## **APPENDIX A**

### **Terms of Reference**

**SUBJECT:** Fieldgate Southeast Georgetown – Russell Farms Terms of Reference  
Draft Plan of Subdivision and Zoning By-Law Amendment Applications.

TYLin has been retained to complete a Traffic Impact Study (TIS) for the proposed Russell Farm subdivision development located in the Town of Halton Hills, within the Region of Halton ("Halton Region," "the Region").

(Source: traffic volumes from the presentation shared by Jessica Passingham)

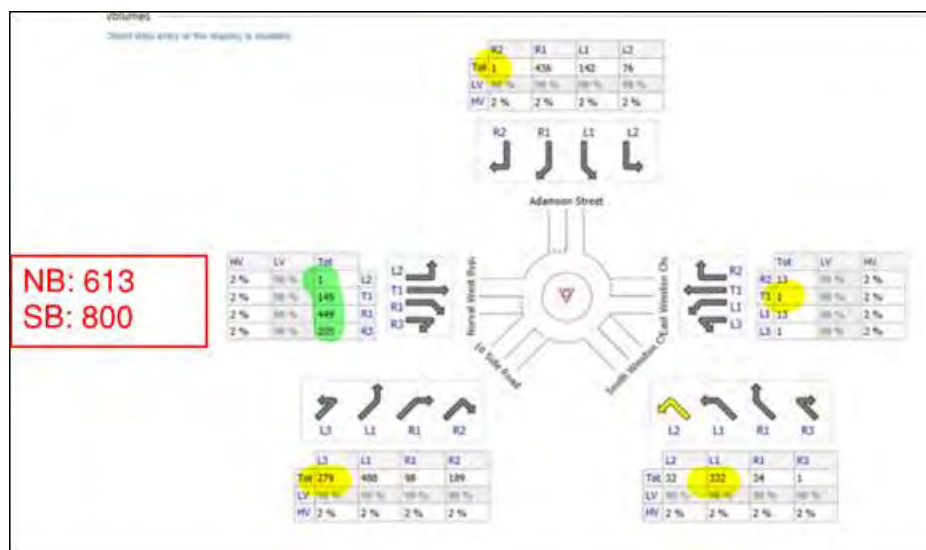
We have observed that northbound and southbound traffic volumes for the Norval Bypass provided in John McMulkin's email (attached) does not match the traffic volumes provided by Jessica Passingham (attached for reference).

For scenario with Winston Churchill Bypass :

**From Jessica's presentation:**

NB volumes on Norval Bypass is :613

SB volumes on Norval Bypass is 800

Please advice which volumes to be used at the roundabout for our analysis.

Please use the most recent (higher) values, that were included in John McMulkin's email, as these were provided most recently (2025) and directly from the same department Jessica Passingham works in, but are MORE RECENT than the lower values (from 2023) that you are comparing too.

As such, please use the higher values:

NB volumes on Norval Bypass: 1350

SB volumes on Norval Bypass : 900

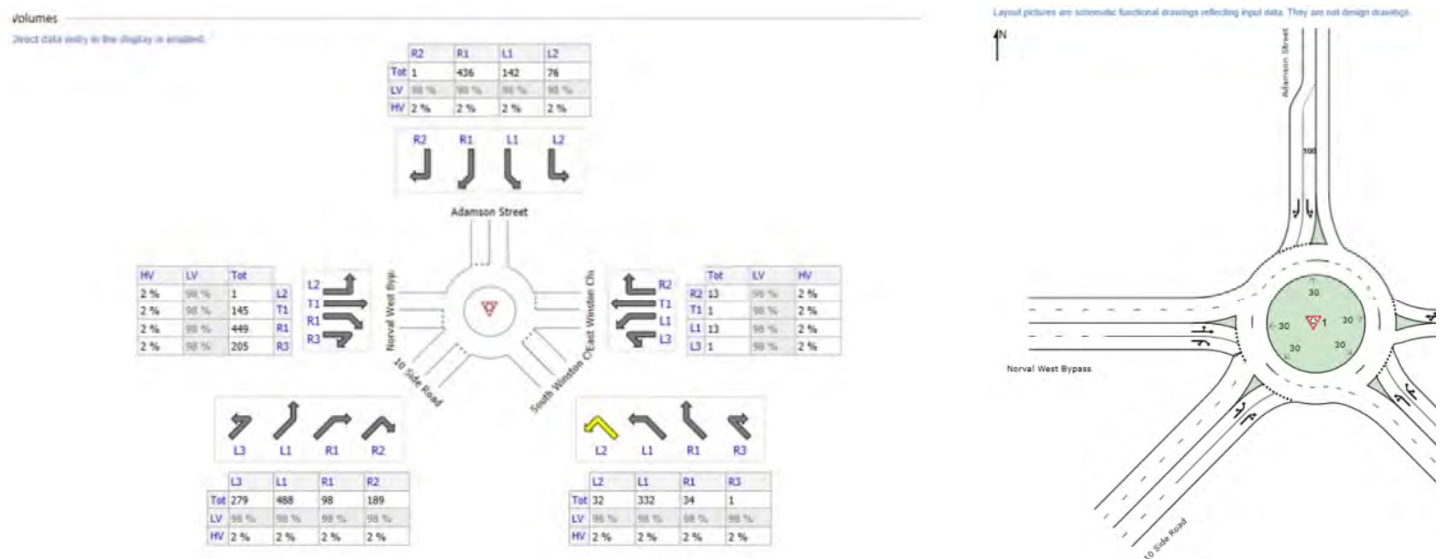
Further to our discussion, we have the following traffic volumes available for the scenario with Winston Churchill Bypass obtained from page 6 of the Norval West Bypass MCEA presentation dated August 10, 2023 (attached for reference). Could you please provide traffic volumes at the roundabout for the scenario without the Winston Churchill Bypass?

Also, we believe that proposed north roundabout at Guelph Street is not required to be included in our analysis as we would expect our site traffic to enter or leave via north leg of the roundabout only. We would not be adding any site traffic southbound on Guelph Street. Please confirm if you agree with this.

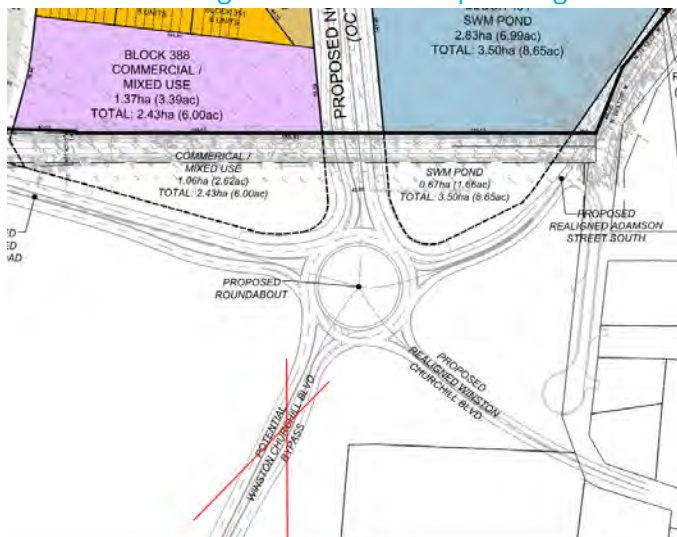
- 1) Regional staff also request an analysis with and without the fifth leg of the Winston Churchill Boulevard/10 Side Road/Norval West Bypass roundabout (i.e. with and without the Winston Churchill Bypass) – **TYLin understanding is that we will not be analyzing this roundabout as it has been considered in the Norval West By-Pass MCEA study so please explain the purpose of analyzing two scenarios i.e., with and without the Winston Churchill Bypass. Also, please confirm if scenario without the Winston Churchill Bypass means removal of the leg crossed in red as per image below:-**
